# **Groundwater Management District #5**

## **Technical Assessment of City of Hays Water Transfer/ R9 Ranch Development Scenarios and Commentary on WaterPACK Analysis**

On February 20, 2018, GMD#5 provided Balleau Groundwater, Inc. (BGW) a Burns & McDonnell (BMcD) analysis of wellfield development at the R9 Ranch and the associated hydrologic effects on the surrounding aquifer.

Balleau Groundwater, Inc. (BGW) reviewed the BMcD analysis and developed this presentation to provide GMD#5 information to assess the change in water use.

# REVIEW OF BMcD ANALYSIS: Stream routing/Elimination of local runoff

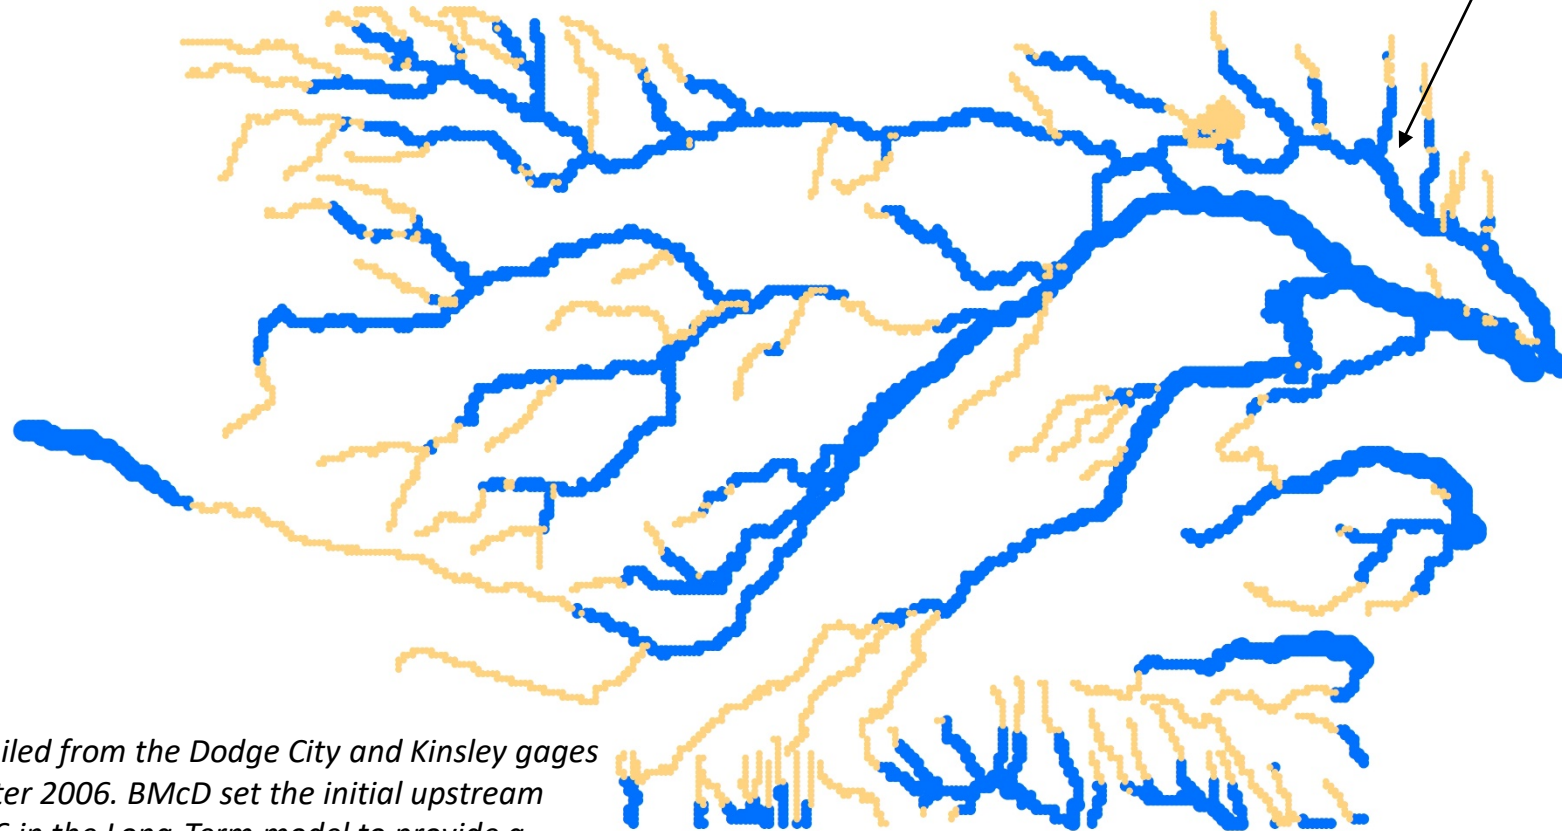
BMcD adjusted the simulated river stages (an average of 1.6 ft lower regionally). The adjustment may have been inadvertent as BMcD reports *“BMcD did not make any changes to ... the GMD5 model.”* We found that, during low flows, the adjustment To the stream stages results in increased flow at the Kinsley gage on the Arkansas River (about five miles downstream of R9 Ranch).

The GMD#5 model is calibrated with recharge from streams that requires routing of downstream flow.

*"Historic flow data in the Arkansas River compiled from the Dodge City and Kinsley gages reflect a significant decrease in streamflow after 2006. BMcD set the initial upstream flow in the Arkansas River to zero after year 16 in the Long-Term model to provide a conservative estimate and to recognize changing conditions resulting in reduced flows in the Arkansas River. Baseflow can still occur if the model calculated water level elevation in the aquifer rises high enough to cause the aquifer to discharge to the River. If that occurs, the streamflow routing package will calculate a discharge from the aquifer to the stream and generate baseflow for the River."*

## REVIEW OF BMcD ANALYSIS: Stream routing/Elimination of local runoff

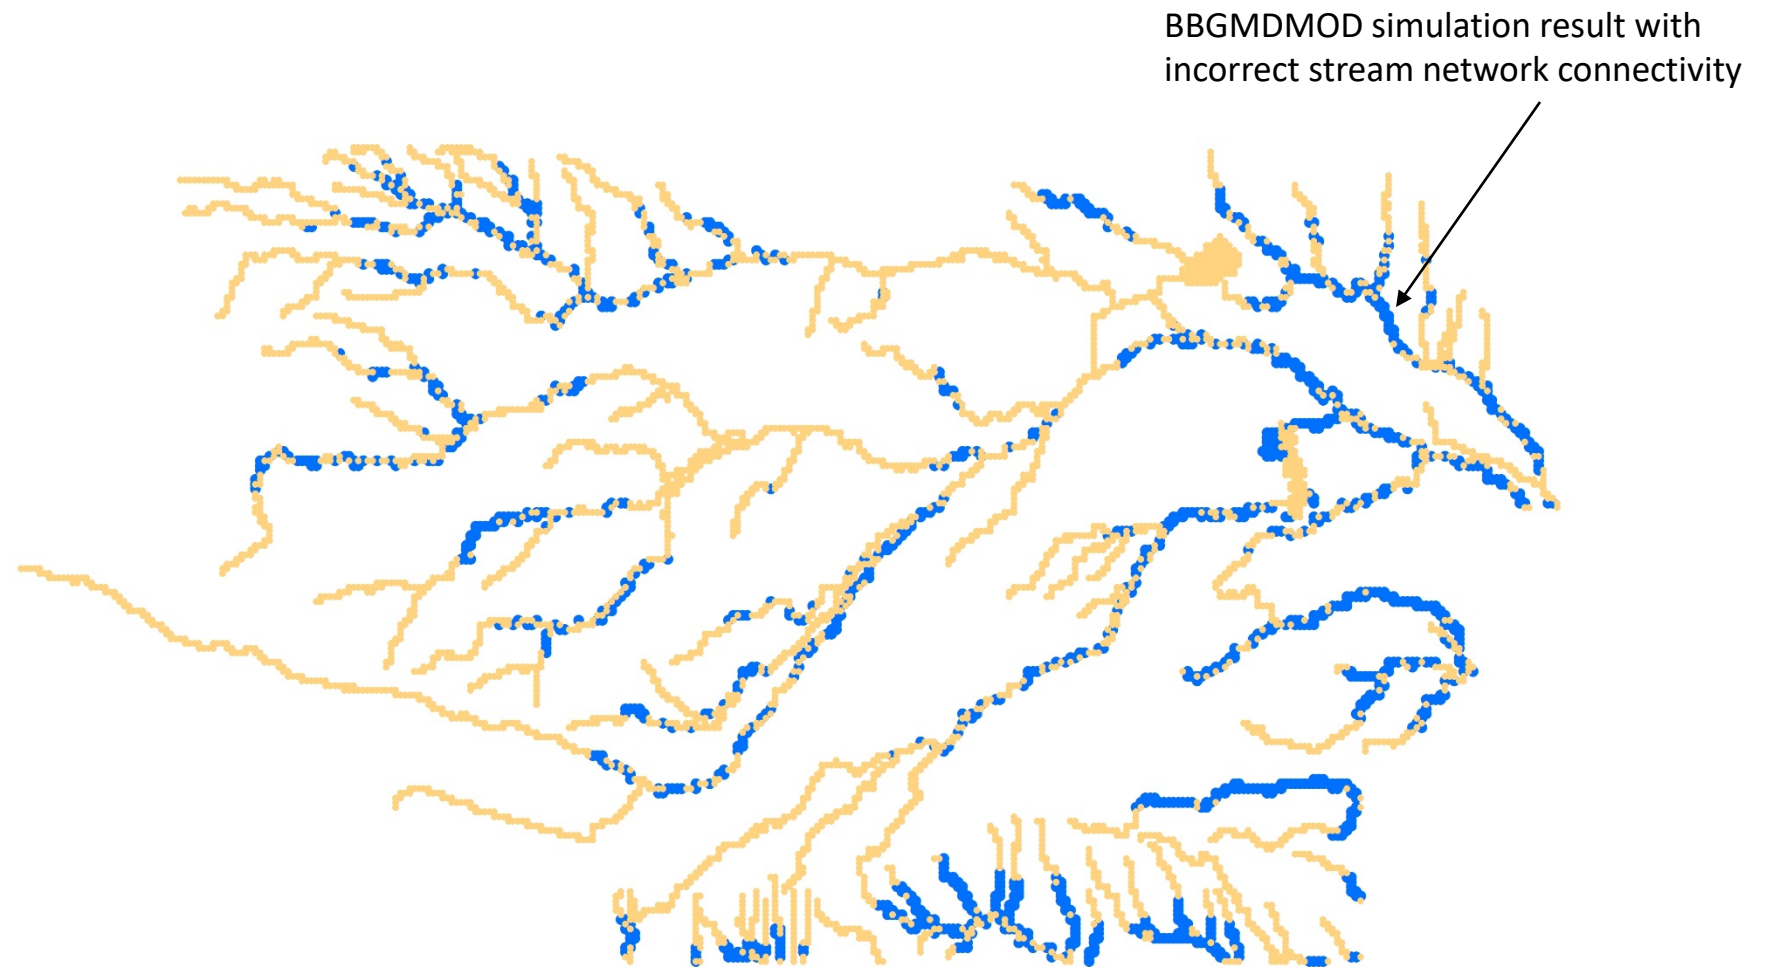
When BMcD set the initial upstream flow in the simulated river to zero (at year 16), the streamflow routing was disabled to create the incorrect stream network connectivity shown above.

# Comment on BMcD Simulation of Stream Stage and Stream Flow Routing

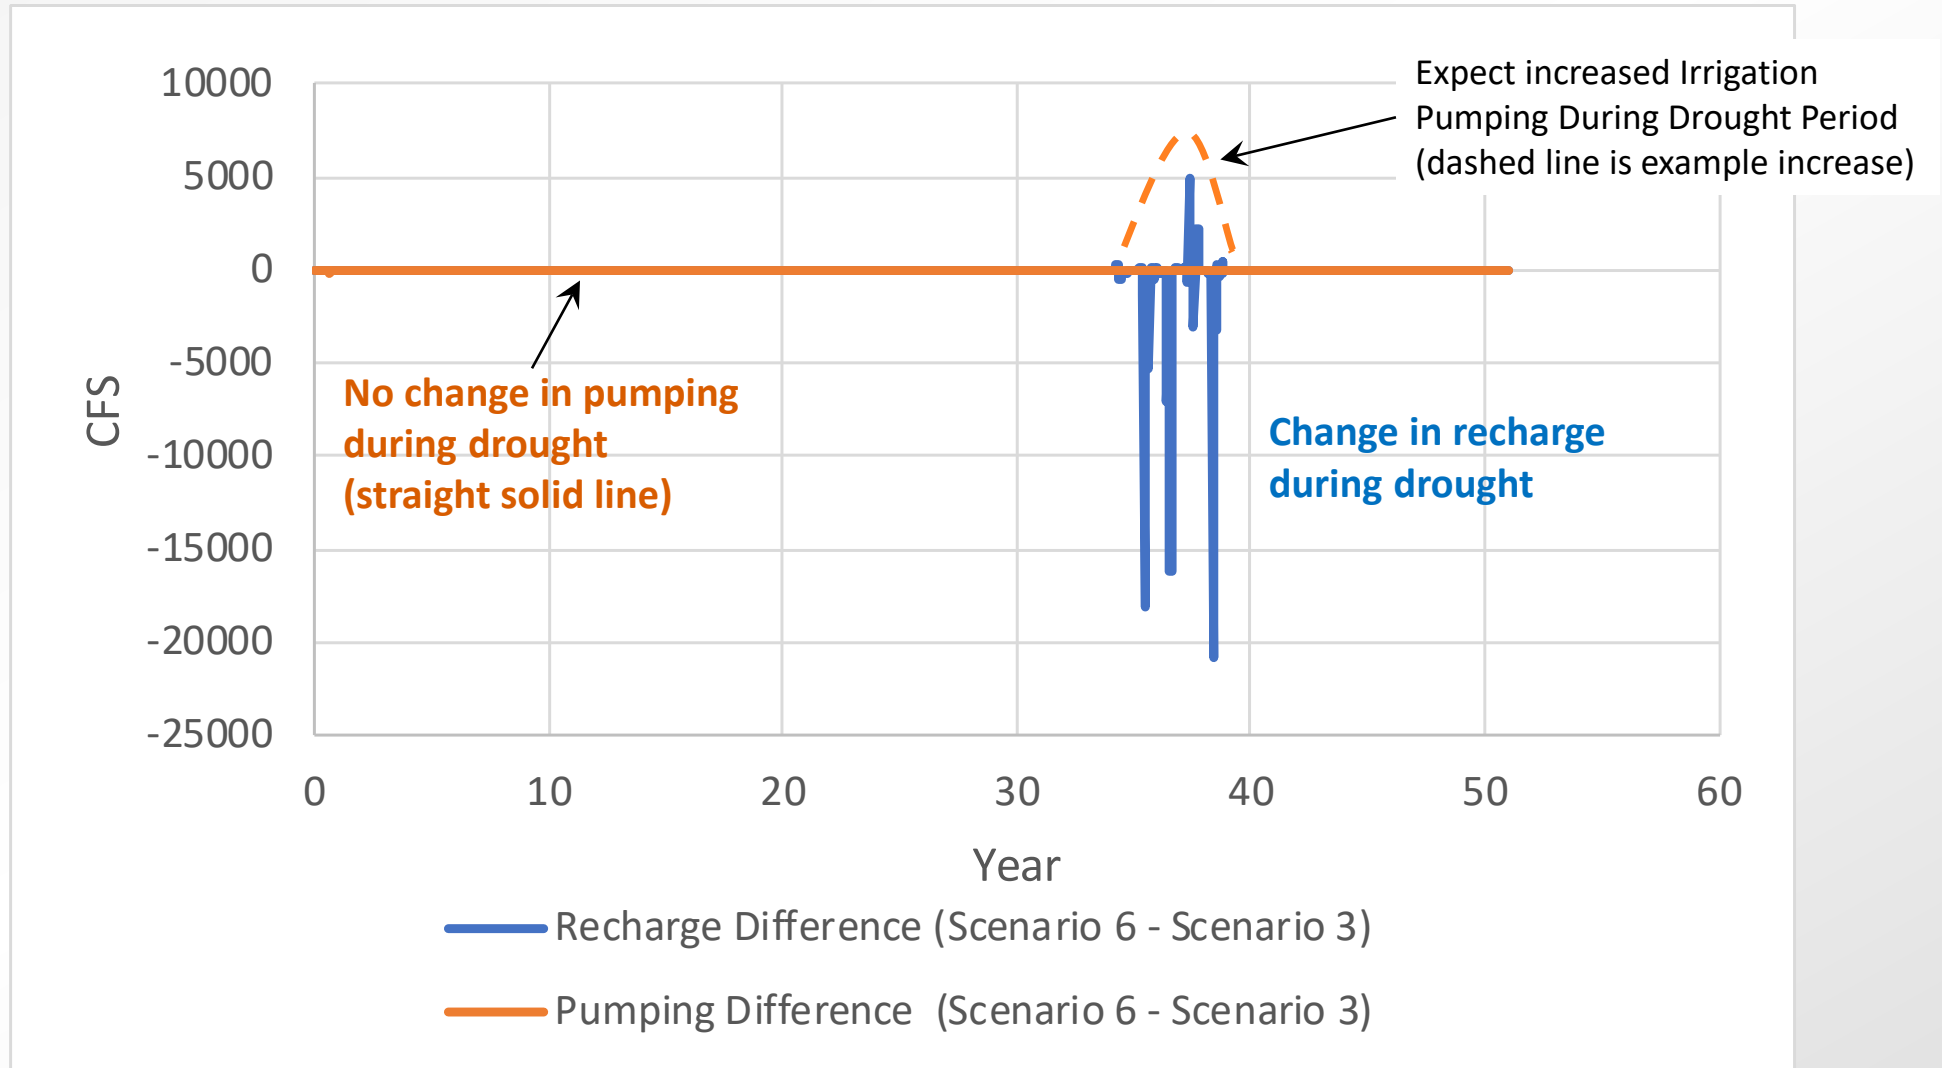
On the average, the simulated stream stages in the BMcD analysis results in regionally incising the streambed a couple of feet in comparison to the calibrated model. This can explain the increased flow simulated at Kinsley gage during low-flow periods (lowering the streambed would induce river flow from shallow groundwater). The issue occurs in both the retrospective and the prospective BMcD analyses.

SFR in the GMD#5 model is the mechanism for aquifer recharge along streams (derived from regional runoff) in the model area. SFR also accounts for flow in the modeled streams. The issue occurs in the BMcD prospective analyses.

The two model adjustments above change the model in a way that may or may not significantly alter the simulated flow regime. The bottom line is that if BMcD were to address the issues by repairing the modeled stream stage and the SFR, their updated results might not be significantly different. The reason is the BMcD model scenarios are based on a difference between two simulations and even though each simulation has an issue with stream stage and SFR, the difference between the scenarios may not be very different from the difference between two simulations with corrected issues. This point can be definitively clarified by re-running the BMcD scenarios with stream stages and SFR that matches the original GMD#5 model (as BMcD reportedly intended).

The BMcD stream stage and streamflow routing (SFR) issues constitute a breakdown in running the GMD#5 model in its calibrated form. It is possible that if the issues are addressed, the BMcD analysis results will not significantly change. However, a technical addendum that addresses the issues should be made to confirm the analysis results as part of the record.

## Comment on BMcD Simulation of Scenario 6 Drought Condition

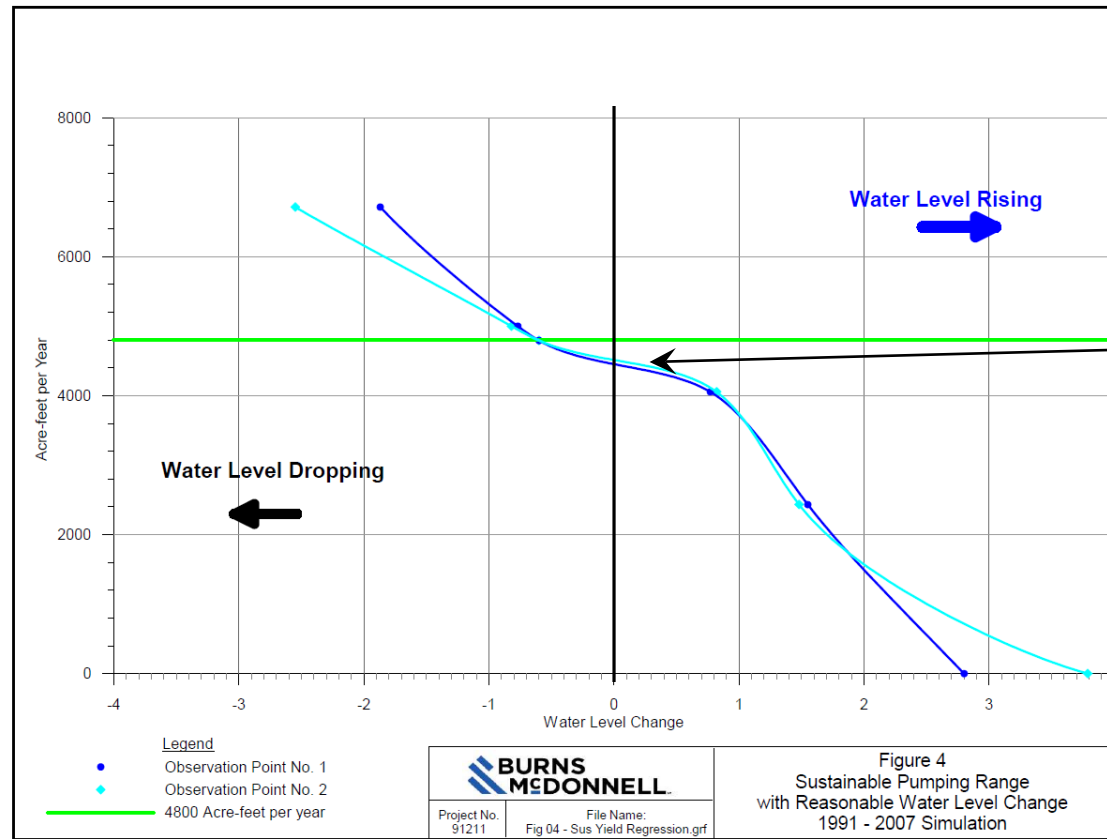
BMcD analysis considers a 5-year drought (Scenario 6) over years 35 to 39 of the simulation. The drought condition is represented by reduced recharge, but without an associated increase in pumping at regional irrigation wells.

It is odd to apply drought conditions to simulated recharge and to the R9 Ranch municipal wells, but not to the other irrigation wells in the area.

In a July 23, 2018 email from David Traster of Foulson Siefkin, LLP, to Orrin Feril, GMD#5 Manager, Mr. Traster indicates the drought scenario was developed at the request of the Chief Engineer and that ultimately the CE “...*elected not to modify nearby irrigation pumping because doing so involved simply too many unknown variables...*” Mr. Traster further characterizes the increased pumping at other irrigation wells to be associated with an inability to predict how it would happen and that it creates uncertainty suggesting the simulation would be speculative. We clarify that the drought simulation would not be an attempt to predict the future, but a scenario to understand the sensitivity of results to an increase in regional pumping associated with drought conditions for planning purposes.

The same technical concept of a difference between two scenarios, previously described for the stream stages and SFR, occurs here. That is, it is possible that if BMcD were to add drought conditions to area irrigation wells and re-run Scenario 6, the results might not significantly change. An actual simulation is necessary to clarify this.

BMcD Scenario 6 considers drought conditions on use of the municipal wells at the R9 Ranch. However, the drought condition is not considered at other area irrigation wells. Consideration of drought conditions in that context would provide a more comprehensive drought analysis for planning purposes. It is possible that re-running may produce similar results despite the better scenario.
